DECISION NO. 69071, APPLICATION NO. 46916 (May 18, 1965)

General Order No. 95 modified to permit the expanded use of polyvinyl chloride conduit (PVC) as a suitable protective covering for risers and runs in overhead electric line construction and also to permit a run terminating in an enclosure to extend to not less than 6 feet of the ground without being treated as a riser.

## APPENDIX A

Figure 61

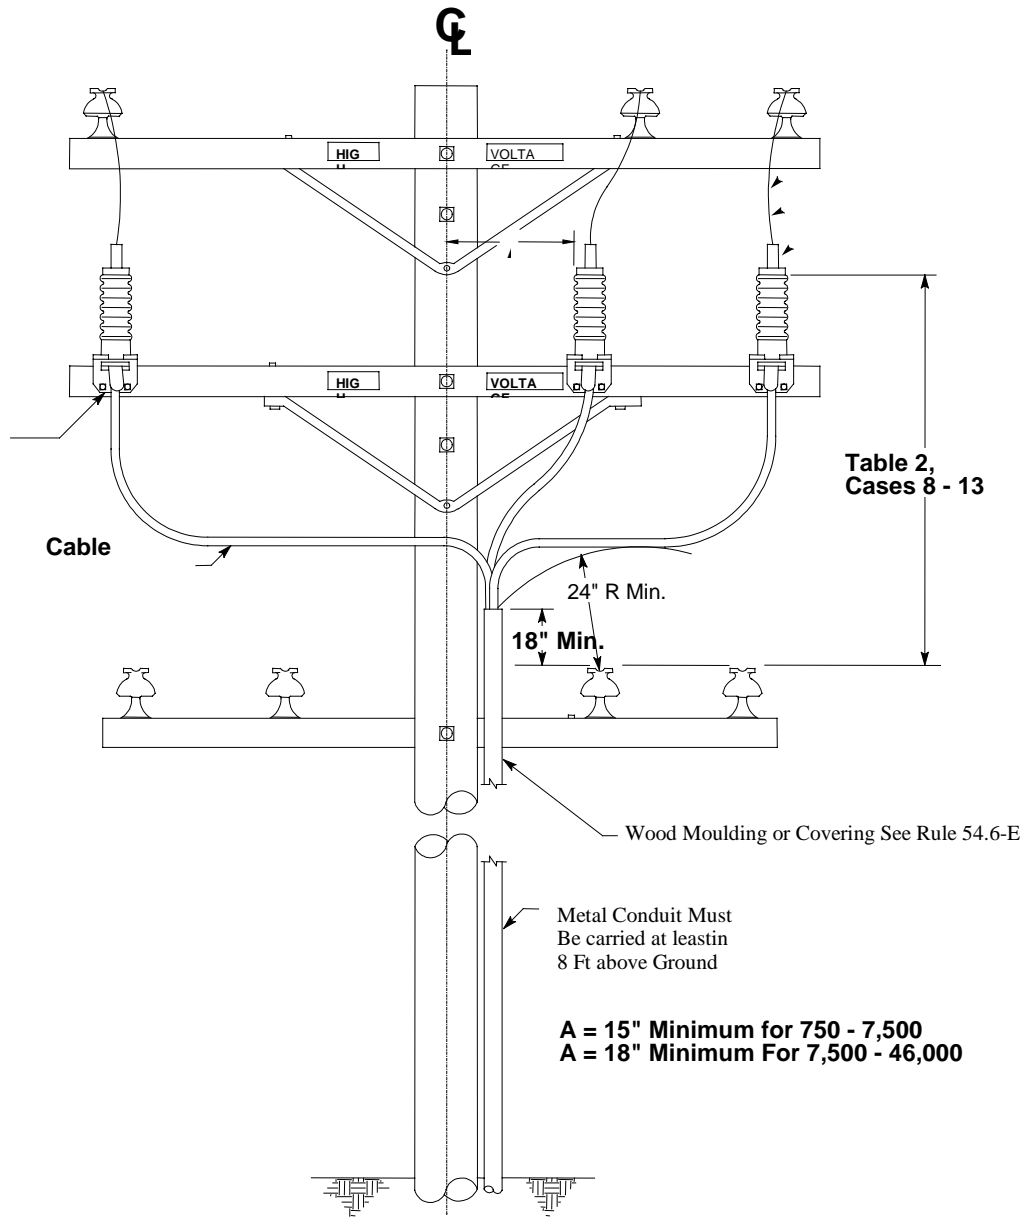
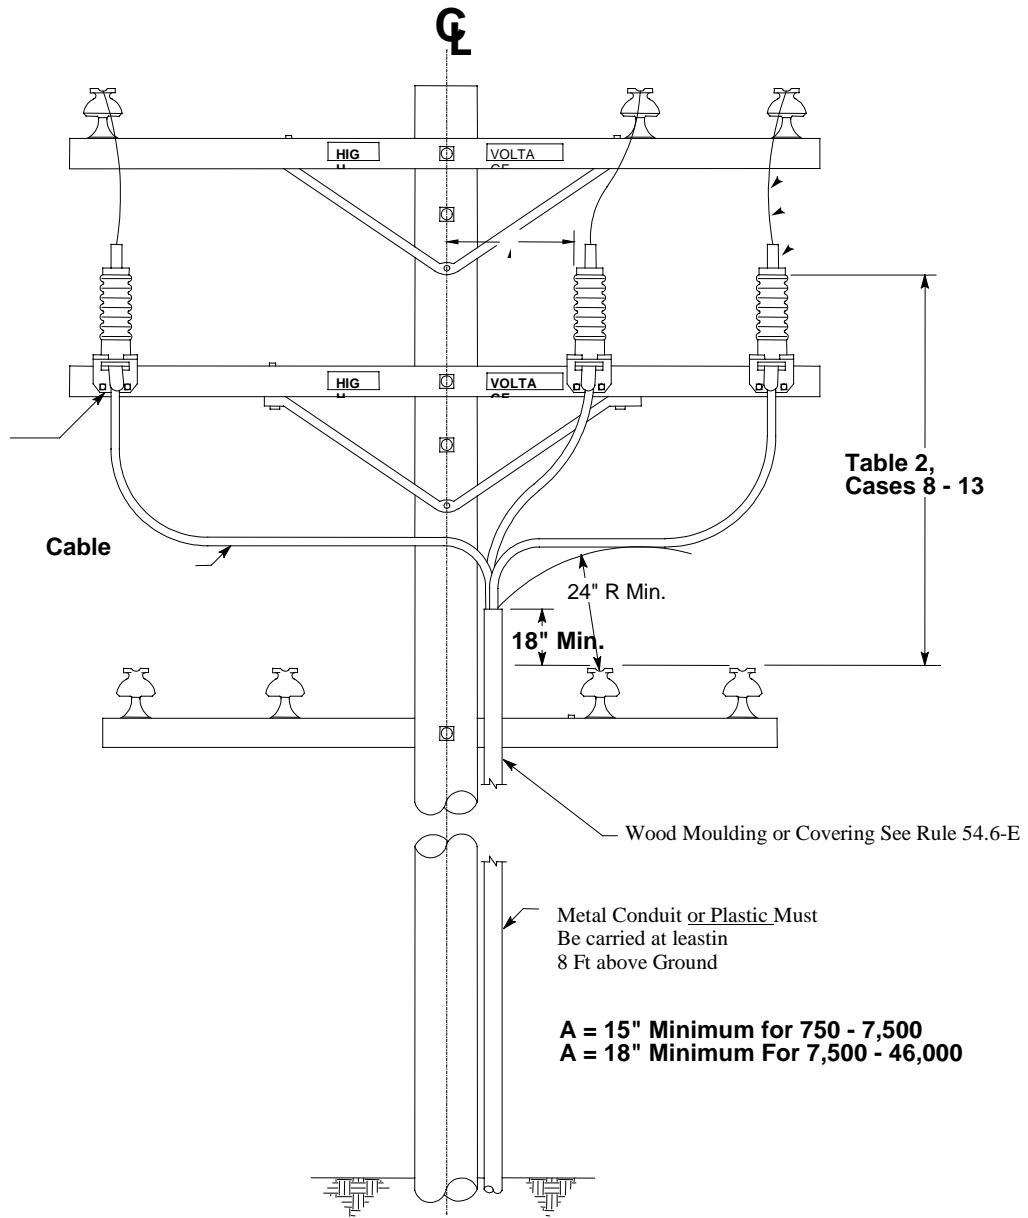
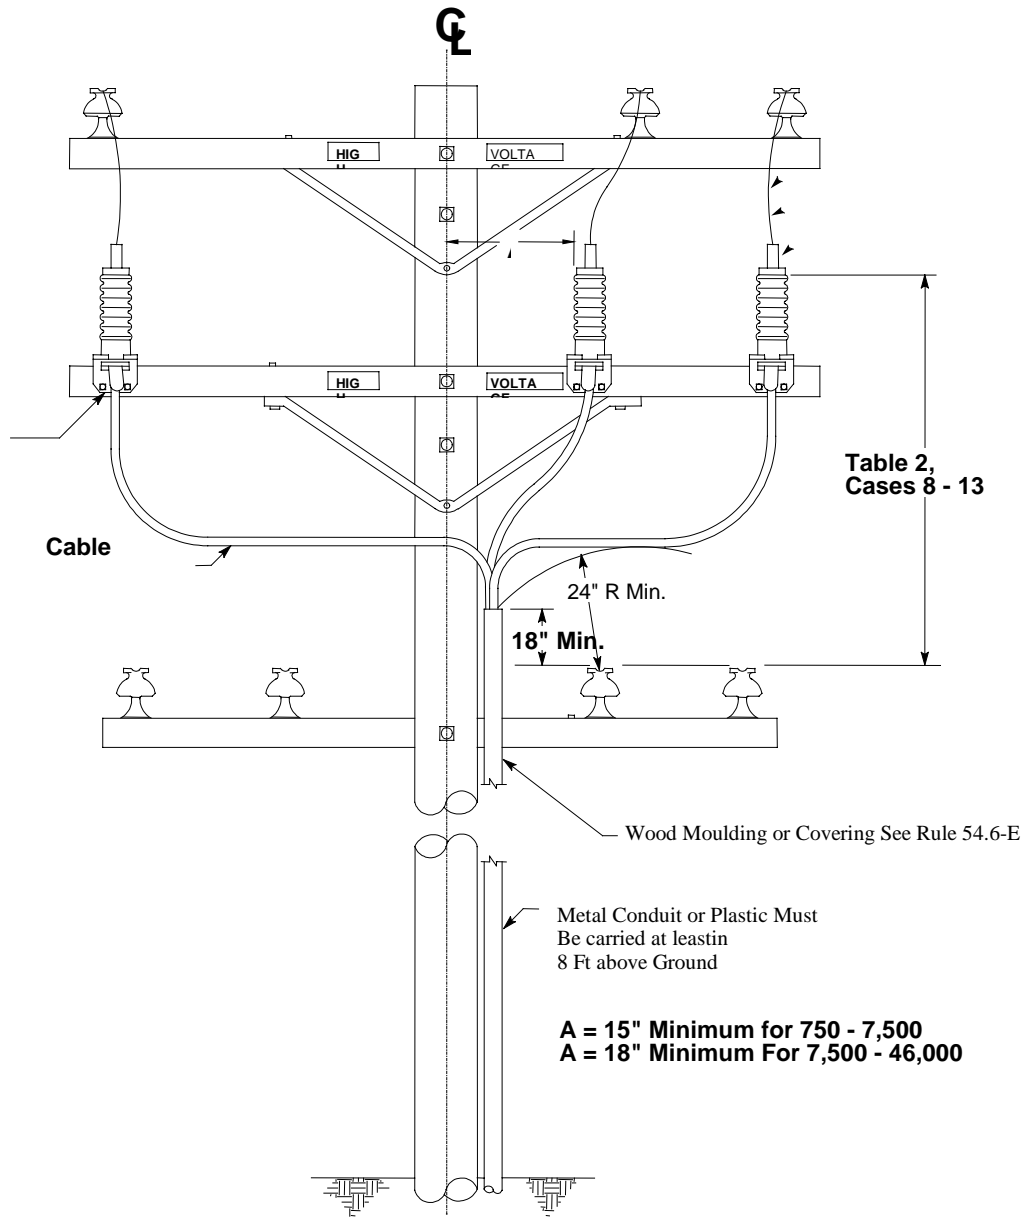
9. Appendix G, Figure 61

The note in reference to metal conduit on this figure is amended to read as follows:

"Metal conduit or plastic pipe must be carried at least 8 feet above ground." (End of Appendix A)
